PROJECT:	LCE-APP-10
PART NUMBER:	80000116
ASSEMBLY NAME:	Zoom SDK Application Kit
SCHEMATICS:	ECR

LOGIC		411 WASHINGTON AVE. N MINNEAPOLIS, MN 55401	
		PRODUCT DEVELOPMENT		PHONE: (612) 672-9495 FAX: (612) 672-9489	
Title Zoom SDK Application Board					
Size C	Number 80000116	Rev G01			
Design Create Date = Monday, July 01, 2002		Project LCE-APP-10	Sheet 1 Of 12

10 - EXPANSION/DEBUG HEADERS

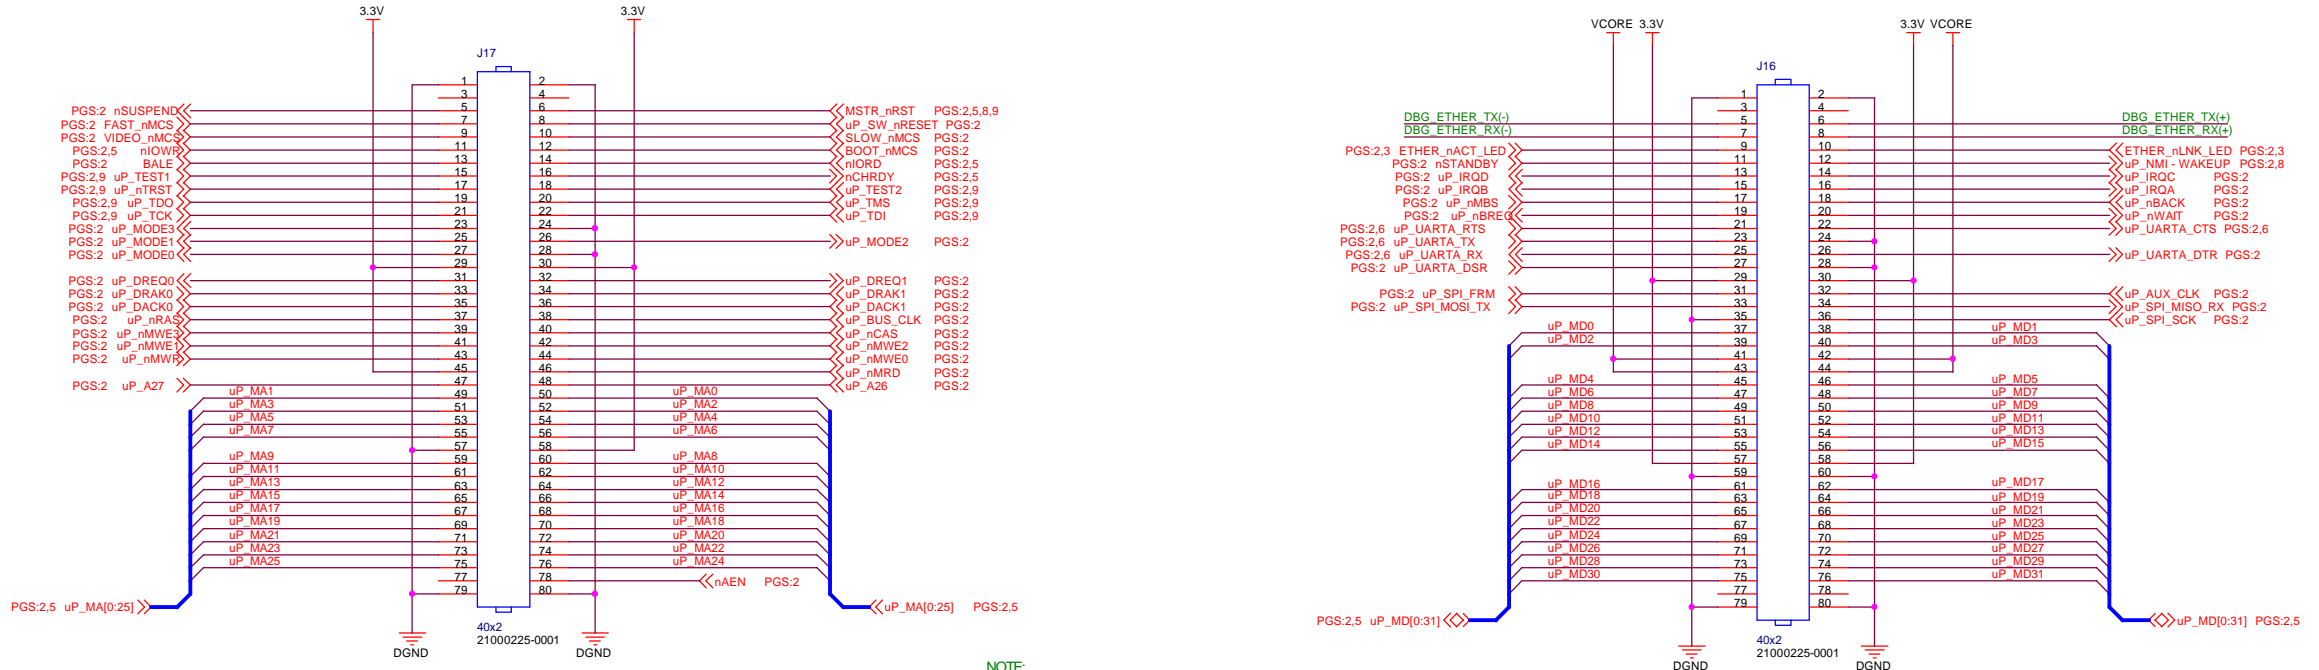
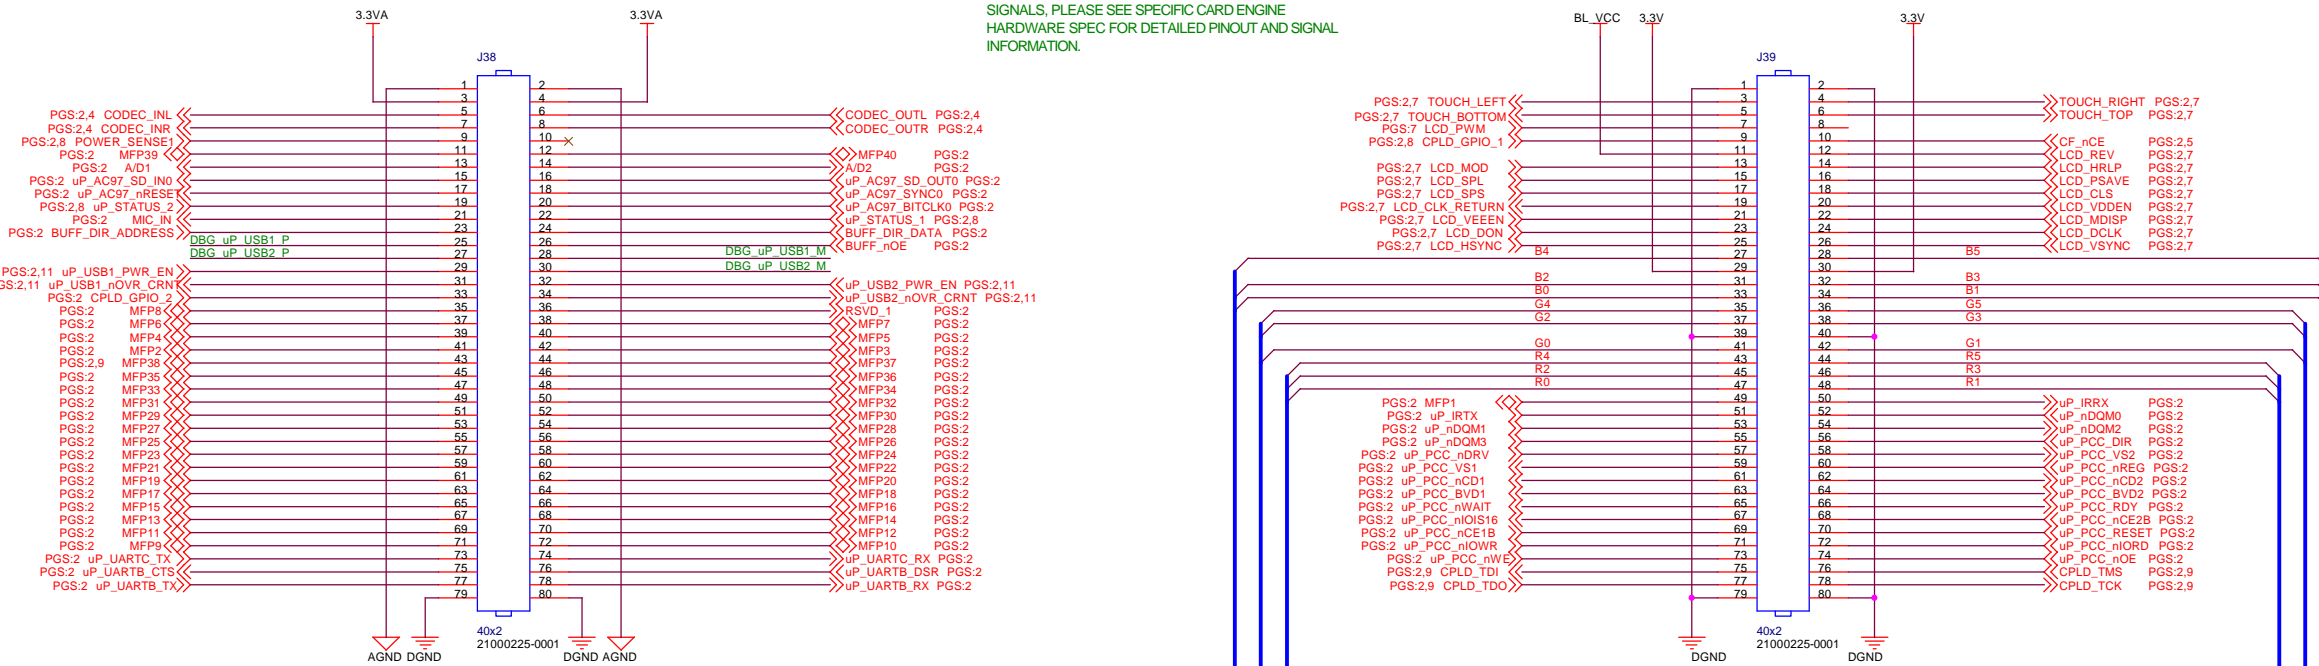
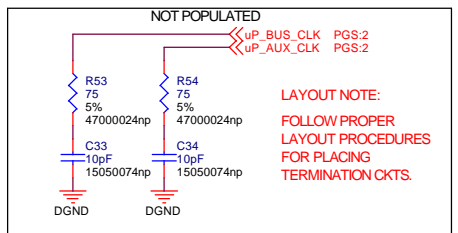
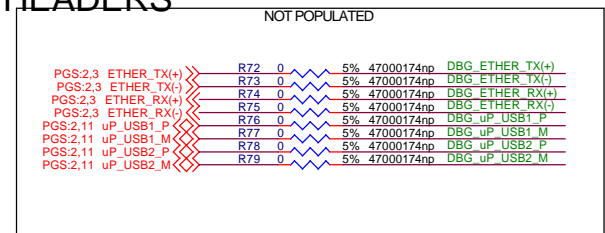
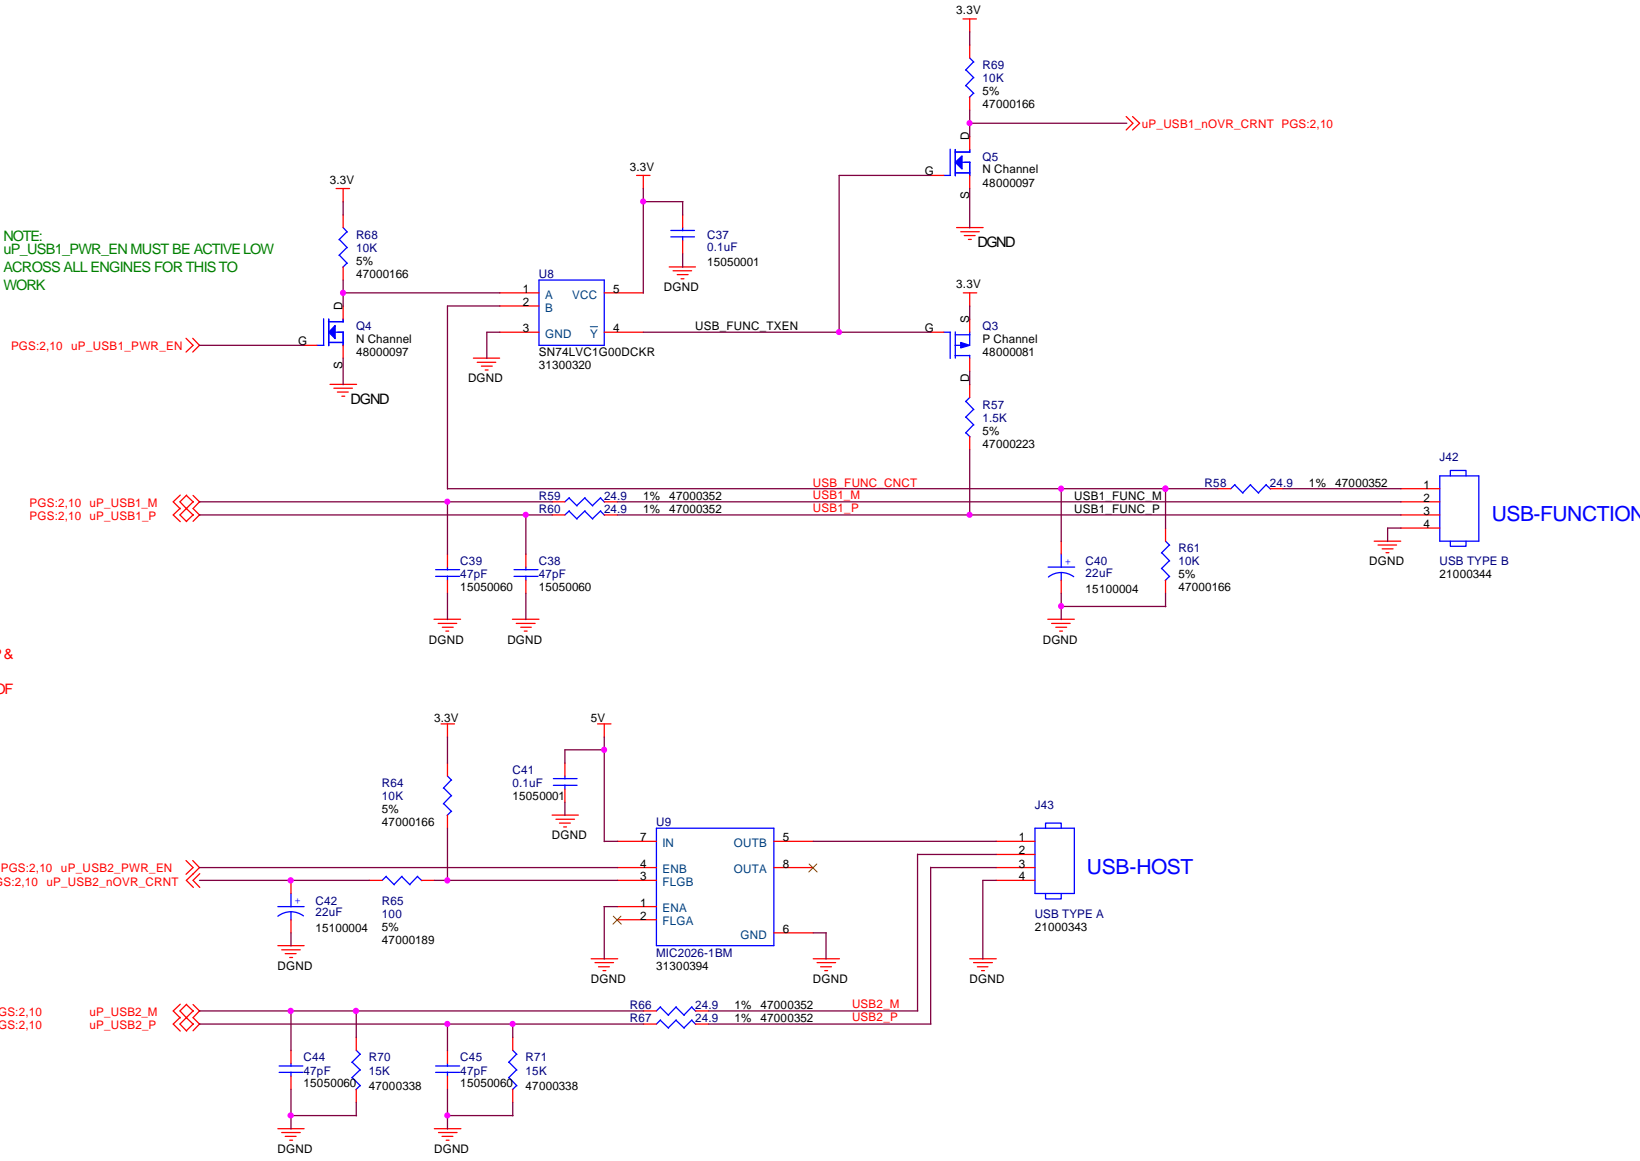
- CHANGED NETS
A39 - TOUCH_TOP (was TOUCHX2)
A38 - TOUCH_BOTTOM (was TOUCHX)
A37 - TOUCH_RIGHT (was TOUCHY2)
A36 - TOUCH_LEFT (was TOUCHY)
- REMOVED THE NET CF_RDYnBSY AND RENAMED THE NET RSVLD_1

- CHANGED NET NAME OF uP_NMI (J16.12) TO uP_NMI - WAKEUP TO ACCOMMODATE THE a400 AND A404.

- ADDED R72 - R79 TO SEPARATE DIFF PAIRS FROM EXPANSION HEADERS

- ADDED TERMINATIONS TO uP_AUX_CLK AND uP_BUS_CLK
- CHANGED NET NAMES TO FOLLOW NEW NAMING CONVENTION SHOWING ACTIVE LEVEL IE. MSTR_nRST -> MSTR_nRST.
- RENAMED NET LCD_CLKIN -> LCD_CLK_RETURN AND NET LCD_CLKOUT -> LCD_DCLK
- SWITCHED THE PINS ON J39 THAT NETS LCD_PSAVE AND LCE_REV GO TO
- CHANGED REF DES OF R53np, R54np, C33np, C34np TO R53, R54, C33, C34

- CHANGED THE NAMES OF THE LCD DATA LINES
- CHANGED THE NET NAMES OF EVB1 AND EVB2 TO CF_nCE AND CF_BSYnRDY RESPECTIVELY
